**LAKE JA-HA DAM
MILLER COUNTY, MISSOURI
MO 30251**

**PHASE 1 INSPECTION REPORT
NATIONAL DAM SAFETY PROGRAM**

SUBJECT: Lake Ja-Ha Dam Phase I Inspection Report

Anderson Engineering, Inc., Springfield, Missouri
Hanson Engineers, Inc., Springfield, Illinois

Profile and Section of Spillway

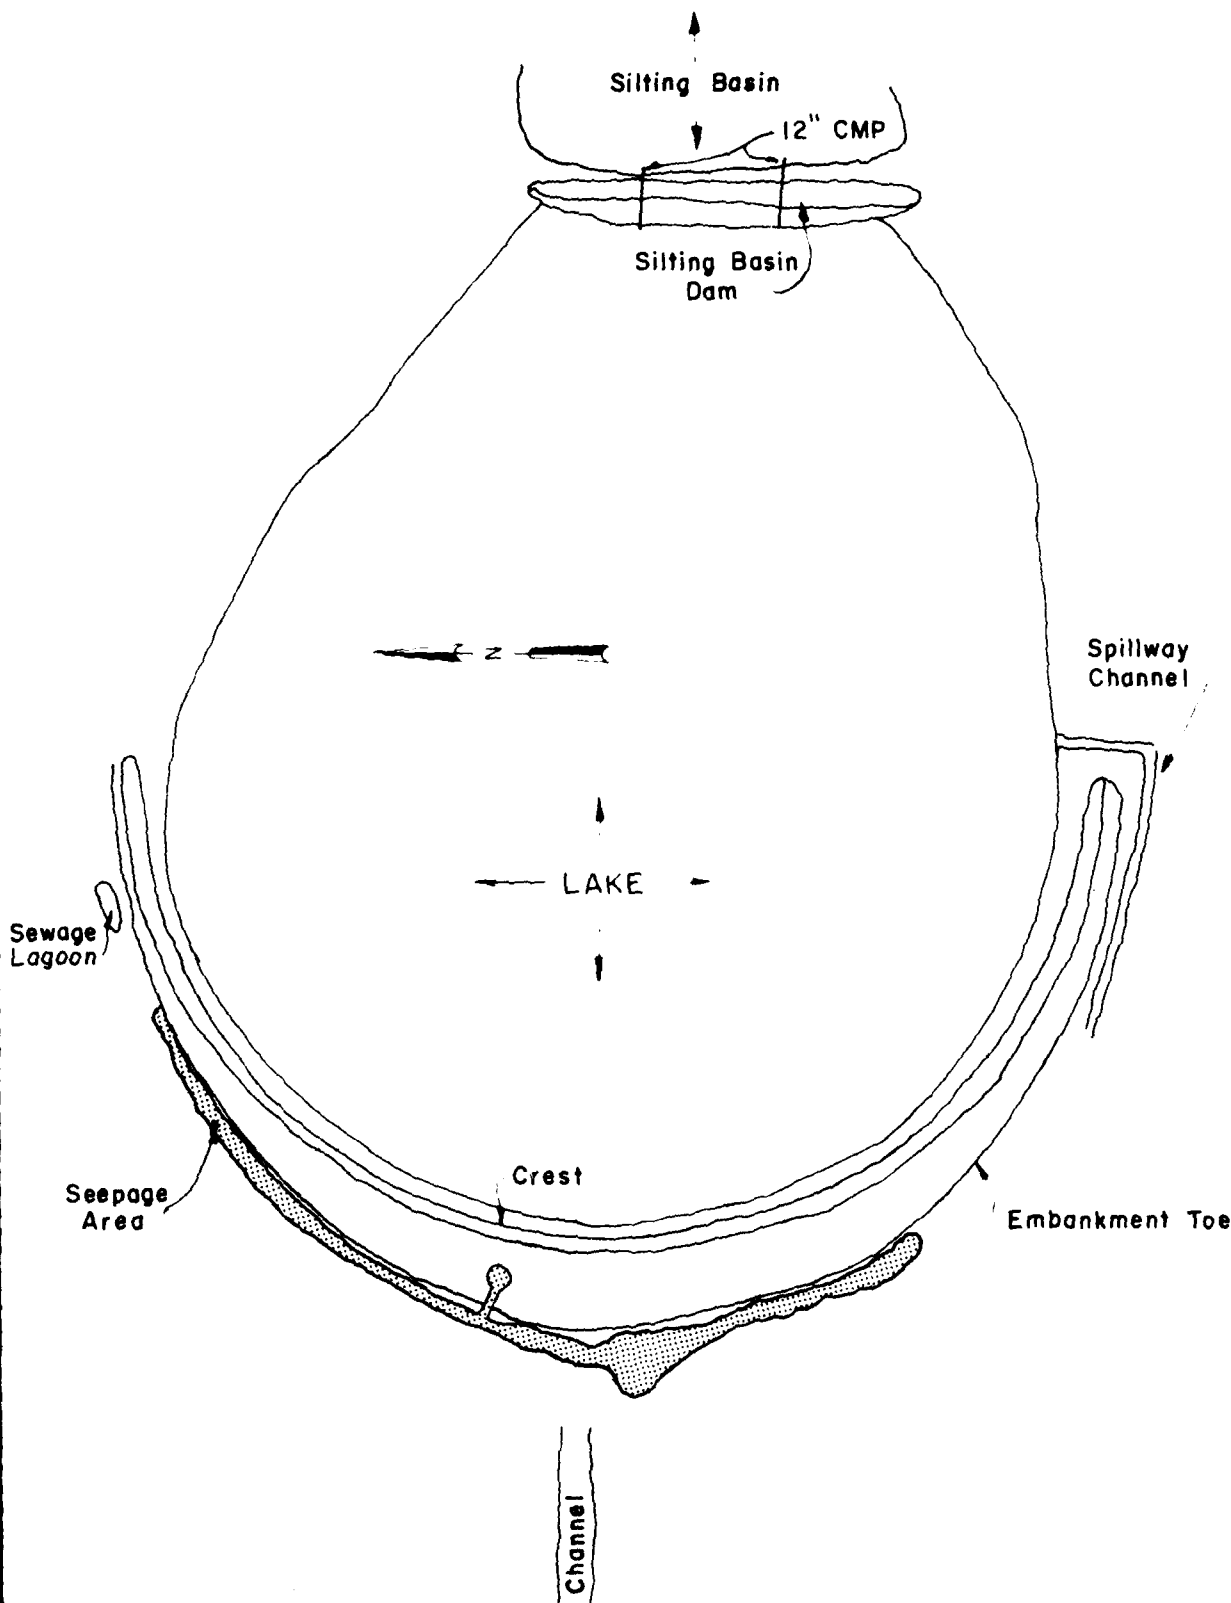
The dam appears to be in generally good condition. The downstream embankment face is heavily overgrown with brush and trees. A small seepage area was noted on the embankment face at about Station 5+00. This area was located about mid-way between the crest and toe and was soft and wet. No obvious flows were observed, and it did not appear that soil particles had been transported from this area. In addition, seepage was observed along a major portion of the embankment toe (see Sheet 4, Appendix A).

- (4) A non-erodible spillway control section should be provided so that progressive erosion of the spillway will not lower the normal pool of the reservoir.

- (5) Wave protection should be provided for the upstream face of the dam.
- (6) The spillway outlet channel should be directed well away from the embankment-abutment contact.

Plan Sketch of Dam

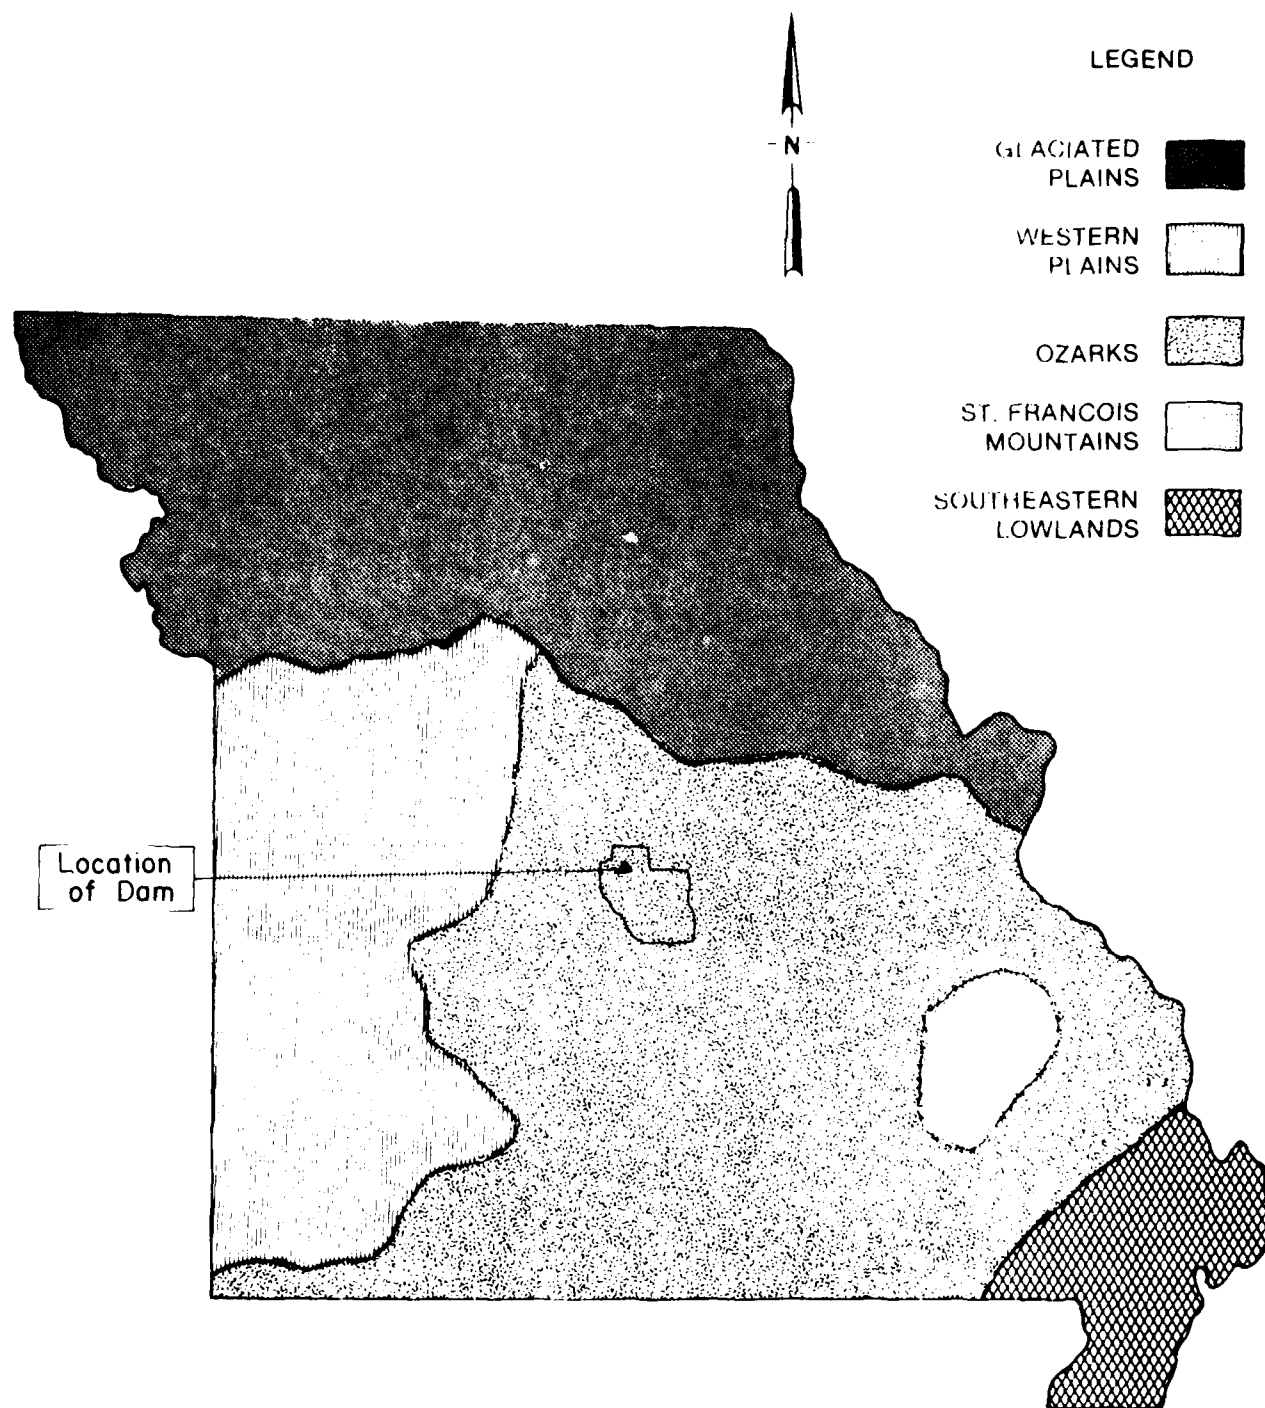
A small sewage lagoon, serving the five homes on the shore of the lake, is located just beyond the embankment toe near the right abutment (see Photo 16). The embankment in this area is only a few feet high. Sheet 5 of Appendix A presents a plan sketch of the dam showing observed features.
